193 CLEARVIEW COURT
1ST Floor

193 CLEARVIEW COURT
NORTH ELEVATION

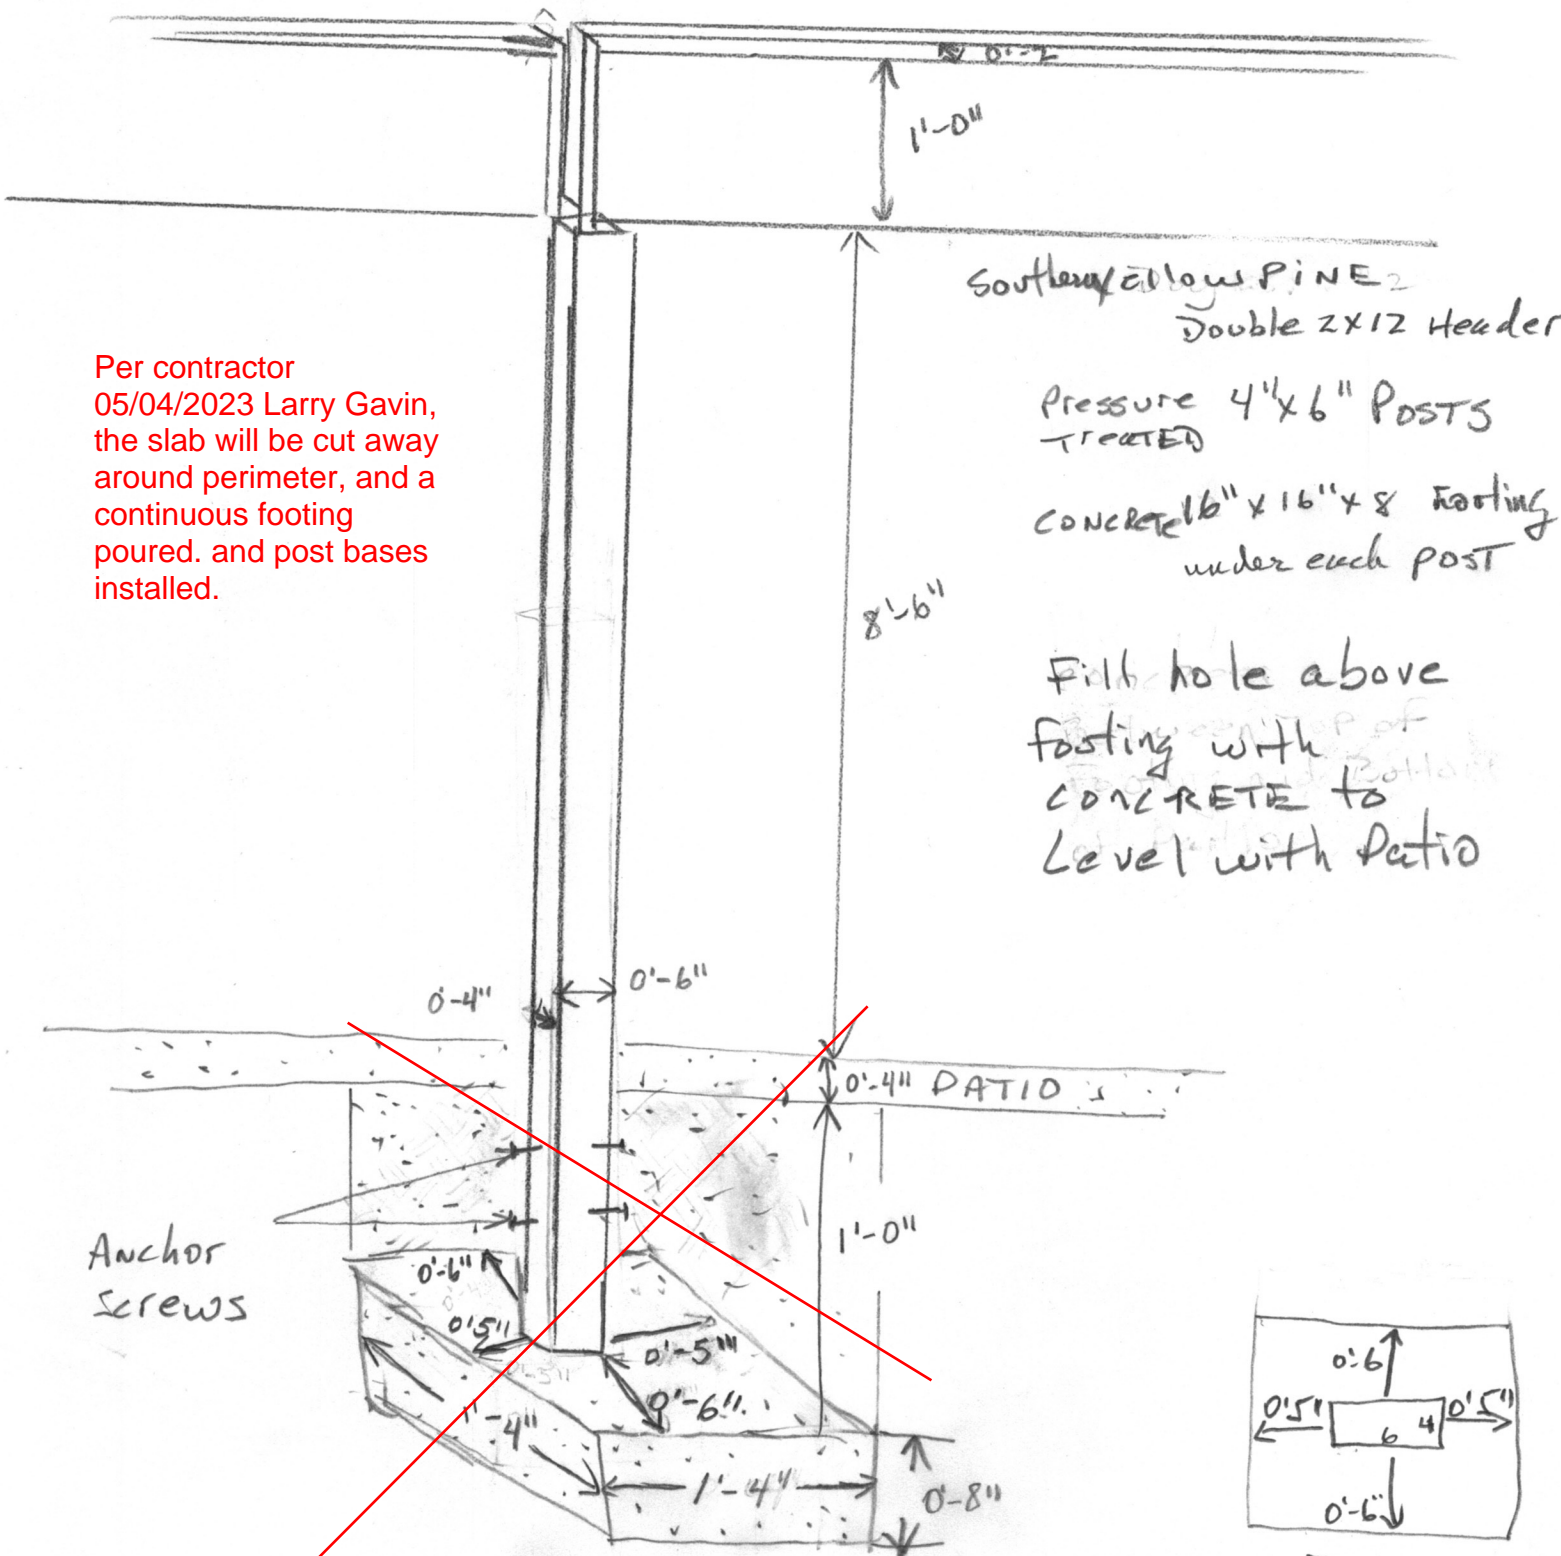
Per contractor
05/04/2023 Larry Gavin,
the slab will be cut away
around perimeter, and a
continuous footing
poured. and post bases
installed.
